Today's Agenda

TAC Comments on Concept Designs

Concept 1 comments on Oak:

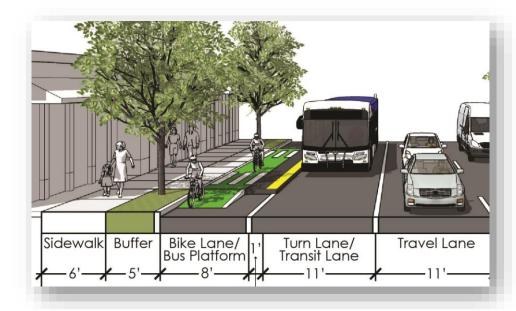
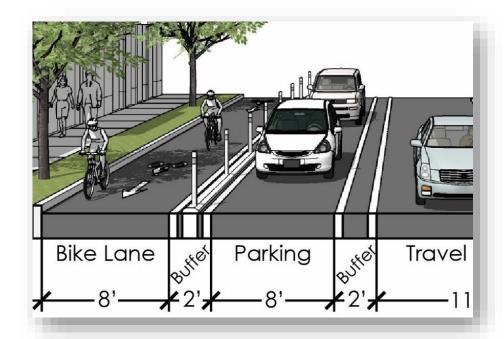
- The cross-section configuration acts as a bus pull-out, inducing delay for transit riders. Desire to locate the bus platform in the parking to keep the bus in-lane.
 - TAC Discussion

- A parking protected bike lane hasn't been done on ODOT facilities yet. Further discussion is needed to vet this as an acceptable alternative.
 - TAC Discussion

Concept 1 comments on Baseline:

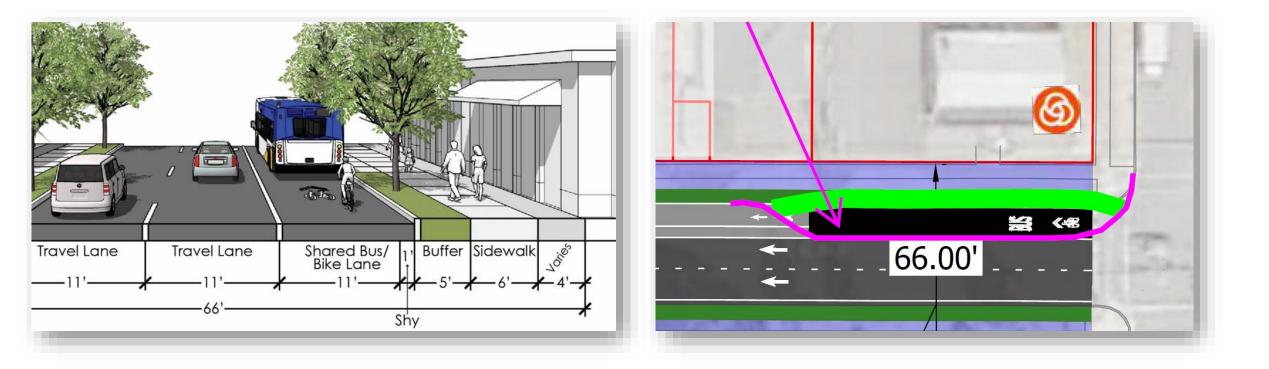
- Bus transition in and out of the bike/bus & general-purpose lanes introduces unnecessary conflicts between cars and buses, and bikes and buses at transit stop while inducing delay for transit riders
 - TAC Discussion

Concept 2 comments on Oak:

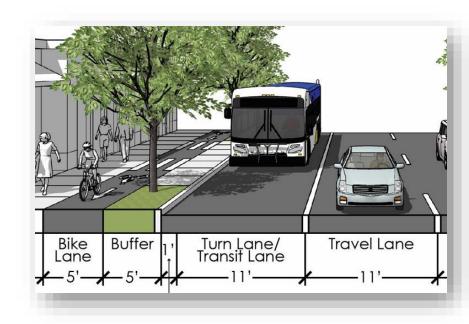
- Bus pull outs will induce delay to transit riders. Future transit project preference is to have curb extension to meet the travel lane.
 - TAC Discussion

Concept 2 comments on Baseline:

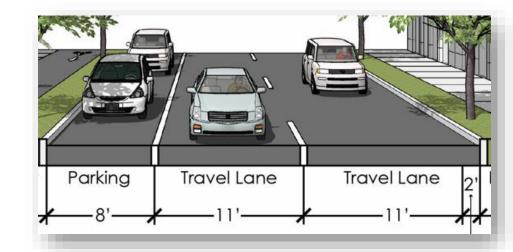
- This option violates the current 29' hole-inthe-air requirement on this RRR.
 - TAC Discussion.
- Recommend bus pullouts on Baseline.
 - TAC Discussion.

Concept 3 comments on Oak & Baseline:

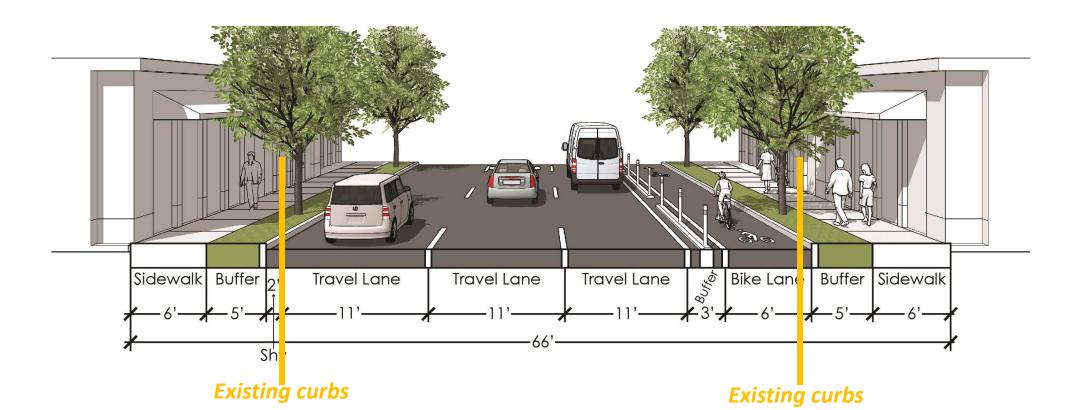
- Piecemealing this option does not work. You would end up with a discontinuous bicycle facility which creates confusion and conflicts on the part of people driving and biking.
 - TAC discussion

Concept 4 comments on Oak:

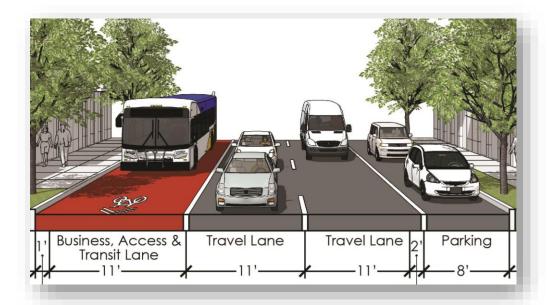
- A BAT lane could be achieved by removing parking, retaining 2 travel lanes, and adding a separated bike lane.
 - TAC Discussion

- General concerns with a BAT lane looking at the number of access points today in this corridor.
 - TAC Discussion

Concept 4 comments on Oak:

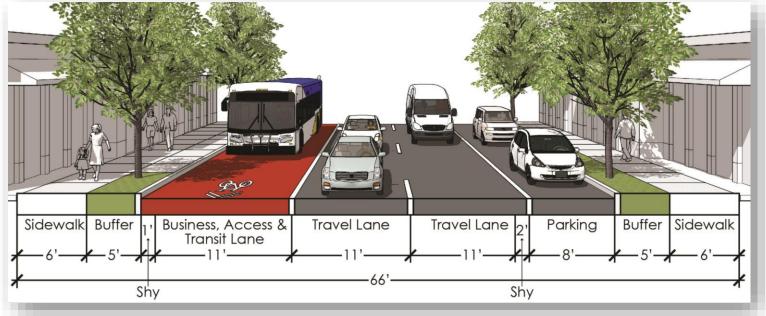
Consider shifting more of the shy distance to the BAT/bike lane so bikes can safely pass a stopped bus. Consider using candle stick separators at the start of blocks and perhaps other locations to help manage traffic.
